**NORM WOOD ENVIRONMENTAL CENTRE UPGRADES
PHASE II**

TENDER 15-46

ADDENDUM NO. 2

January 14th, 2016

**RIGHT SIDE ELEVATION
(ME 110)**

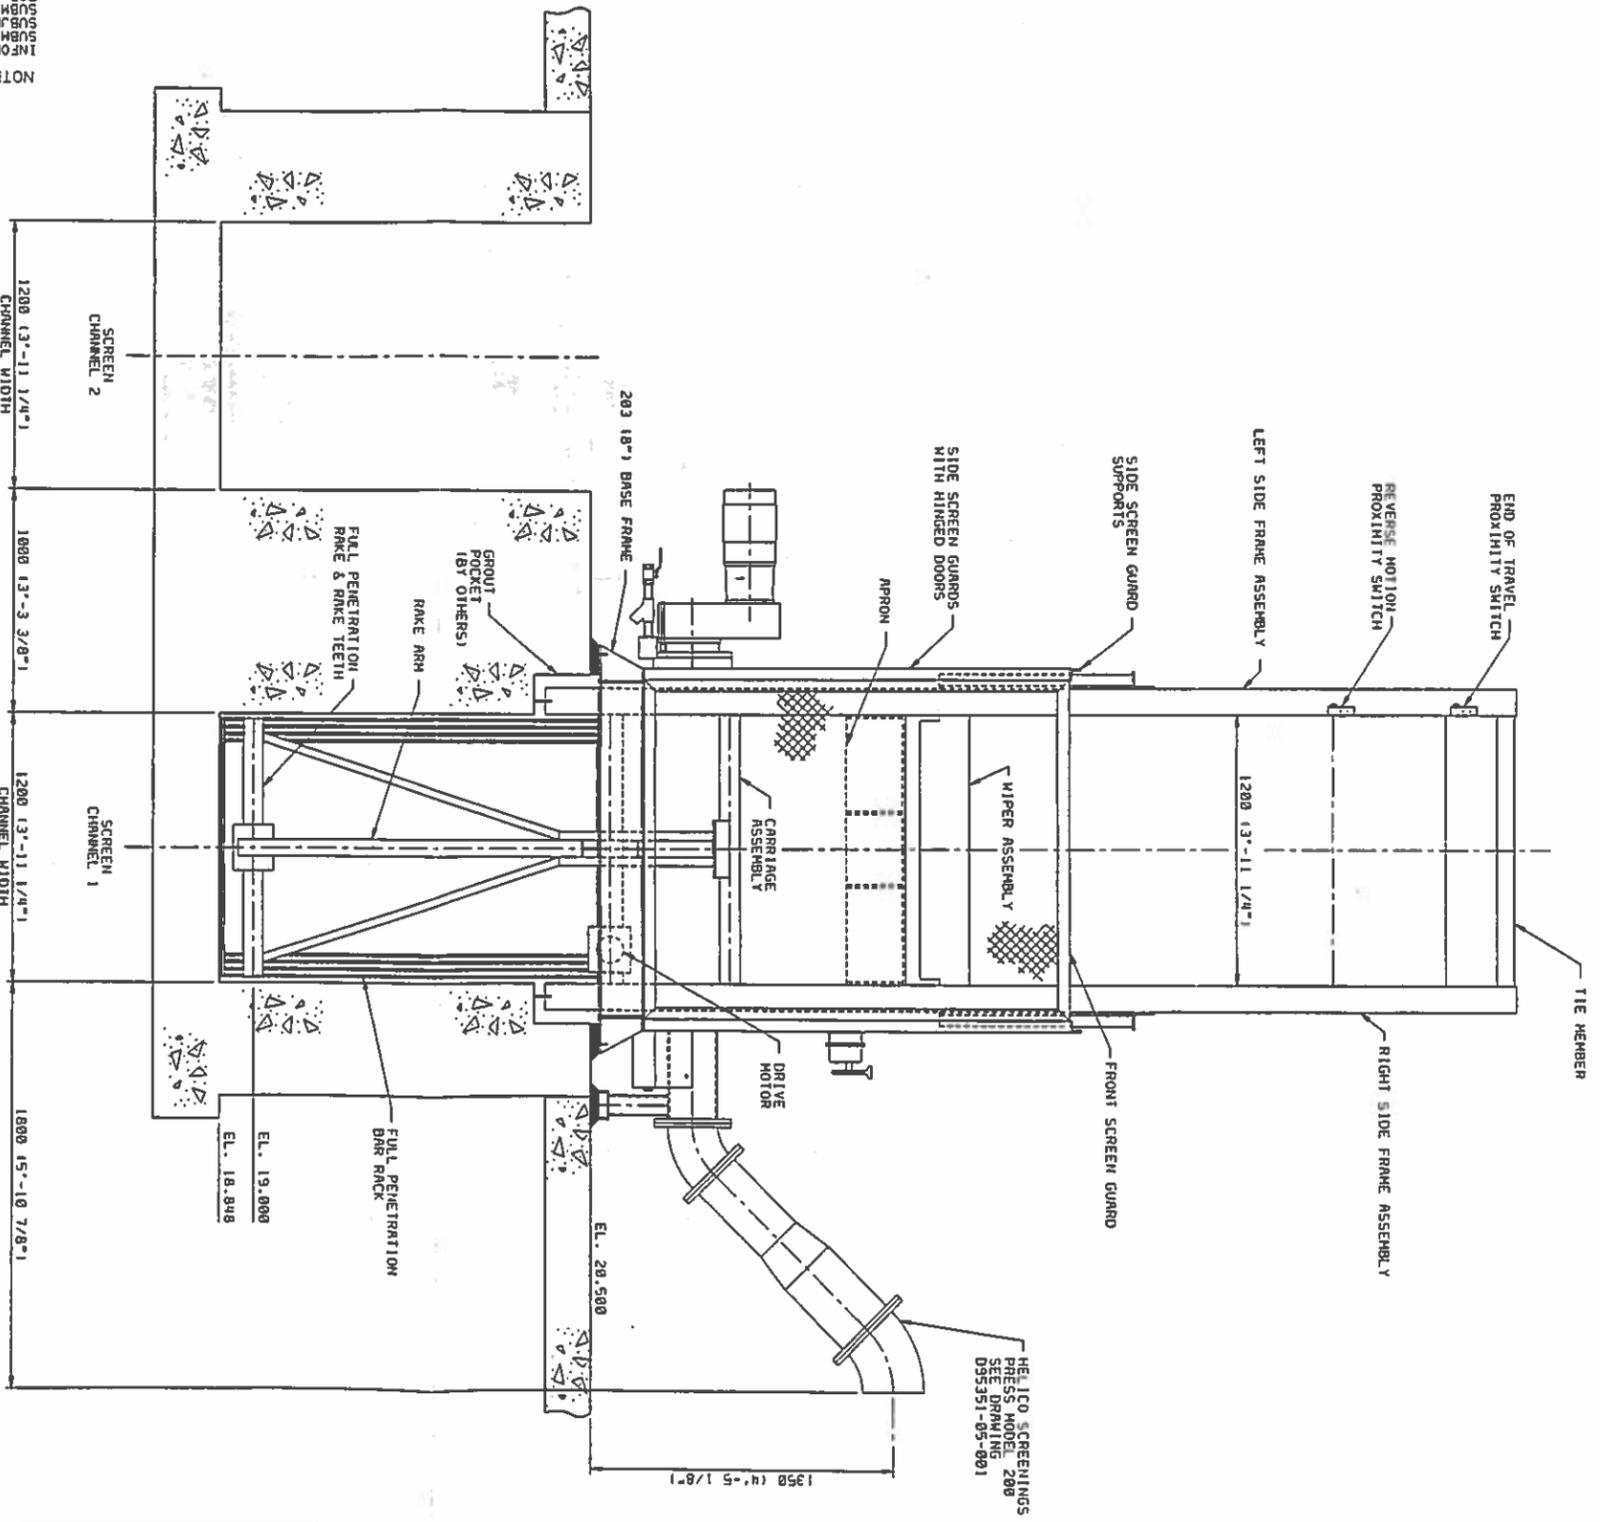
On addendum #1 question 7 does not answer if there are any anchors under the water level that need to be removed. Is the contractor to assume that there are no anchors below the water level that will require the channel to be dewatered to remove?

REFER TO ATTACHED SCREEN INSTALLATION DRAWINGS.
